# Access Compliance Report

## Public Rights-of-Way

### (Curb Ramps)

Intersection ID: 11898	Main Street: ALLEN_ST	Cross Street: E_18TH_ST	Location:	N
ADA ID: 2C82235C9ACD	Ramp Type: BlendTrans1	Initial Pass/Fail: Fail	Overall Compliance: No	Severity Score: 12.5
Codes/Mitigation Info/Possible Solution		Field Measurements/Component Compliance

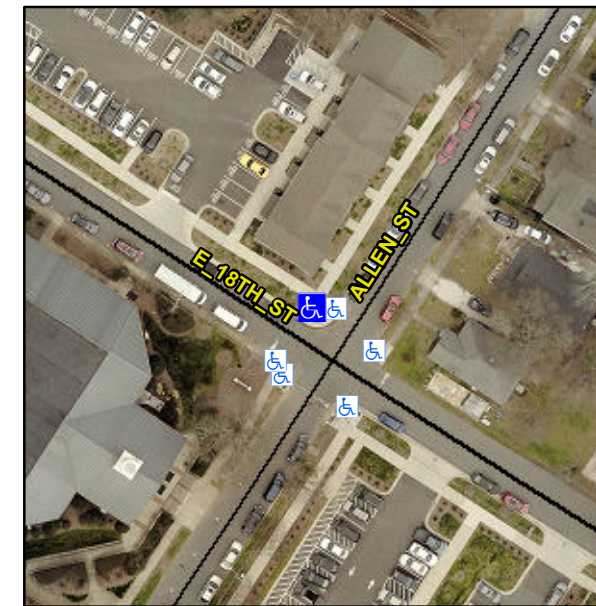
Compliance	Description	Data	Compliance	Description	Data
N/A	Ramp Length (in)	75.0	Yes	BlendTrans Slope (%)	2.2
Yes	Ramp Width (in)	48.0	No	BlendTrans XSlope (%)	6.0
N/A	Flare Type LT	N/A	N/A	Flare Type RT	N/A
N/A	Flare Slope LT (%)	N/A	N/A	Flare Slope RT (%)	N/A
N/A	Flare Traversable LT?	N/A	N/A	Flare Traversable RT?	N/A
N/A	Landing Length (in)	N/A	N/A	DWS Provided?	N/A
N/A	Landing Width (in)	N/A	N/A	DWS Contrast?	N/A
N/A	Landing Slope (%)	N/A	N/A	DWS Length (in)	N/A
N/A	Landing X Slope (%)	N/A	N/A	DWS Full Width?	N/A
N/A	Landing Curb? (Y/N)	N/A	N/A	DWS Offset (in)	N/A
N/A	Shared Landing?	N/A			
N/A	Gutter Ponding?	Yes	N/A	Gutter Slope (%)	N/A
N/A	Gutter Lip Ht (in)	N/A	N/A	Gutter X Slope (%)	N/A
N/A	Painted X Walk1?	No	N/A	Painted X Walk2?	N/A
	X Walk 1 Direction	To SW		X Walk 2 Direction	N/A
	X Walk 1 Width (in)	N/A		X Walk 2 Width (in)	N/A
	X Walk 1 Slope (%)	2.3		X Walk 2 Slope (%)	N/A
	X Walk 1 X Slope (%)	3.7		X Walk 2 X Slope (%)	N/A

N/A	Ramp inside XWalk1?	N/A	N/A	Ramp inside XWalk2?	N/A
	Road Slope (%)	3.7		Clear Space?	N/A
	Road X Slope (%)	2.3	N/A	Clear Space to XWalk (in)	N/A
N/A	Any Obstructions?	N/A	N/A	Storm Grate/Utility Hazard?	N/A
	Obstruction Type			Storm Grate/Utility Type	
		N/A			N/A
			Yes	Surface Condition? (G/P)	Good
			N/A	Curb Slope (%)	2.1

**Remove & Replace Curb Ramp With Two New Directional Ramps or Equivalent.**

**R304.5.3**
